DECLASSIFIED
Authority
By 13526
Date 1/18

NOTE
THIS IS A COINCIDENT CURRENT, 3 HOLE, DESTRUCTIVE READOUT MAGNETIC CORE,

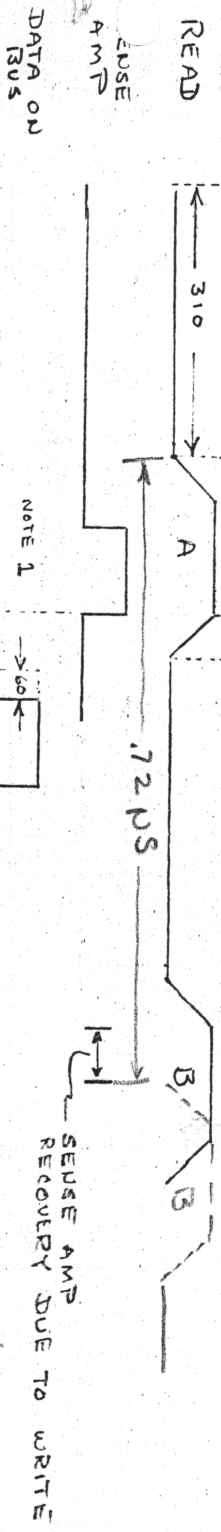
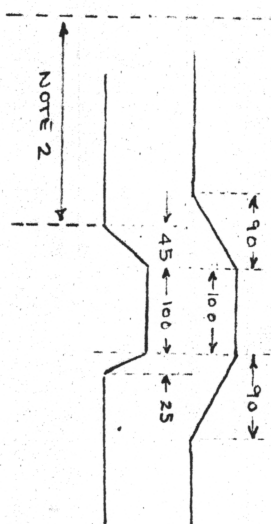
- NOTE 1. DATA COULD APPEAR ON BUS 60 MYS EARLIER THAN SHOWN
2. FROM SENSE AMP TO 2 WINDING, SIG TRAVERSES THRU MIN 5 STAGES (100 MYS) SO WHEN SIG COULD COINCIDENTLY COME UP 20 MYS EARLIER THAN SHOWN

NOTE: THIS TIMING DIAGRAM INDICATES A 72 NS CYCLE IBM CLAIMS A 655-96 NS CYCLE TIME (MEETING BETWEEN AVE6 & MPRO 3 - 24 APRIL) AND 8-10 NS. CYCLE SHOULD BE MORE RELIABLE.

THE ABOVE TIMING DIAGRAM SHOWS THE READ PULSE OCCURRING AT THE EARLIEST POSSIBLE TIME AFTER A SELECT, AND AVERAGE BETWEEN BEST & WORST TIMES THE OTHER SIGS. COULD OCCUR IN SEQUENCE AS TAKEN AND MINIMUM DURATION OF PULSE IS USED, THERE IS ACTUALLY 60 MYS. THE LAST 3 SIGS COULD BE MOVED TO THE LEFT. THIS GIVES NO FACTOR OF SAFETY, MEETS A .60 NS CYCLE TIME, NECESSitates CRITICAL ADJUSTMENTS AND POSSIBLY CONTINUAL ADJ. DUE TO DRIFTING. EVEN WITH .25 NS MEMORY SLOTS (HARVEST THE TIMING IN THE HI SPEED MEMORY WILL BE EXTREMELY CRITICAL, (.75 NS CYCLE TIME) IN ORDER TO IMPROVE SYSTEM SHORTER PULSE DURATIONS FASTER RISE & FALL TIMES SHOULD BE ATTAINED IF POSSIBLE
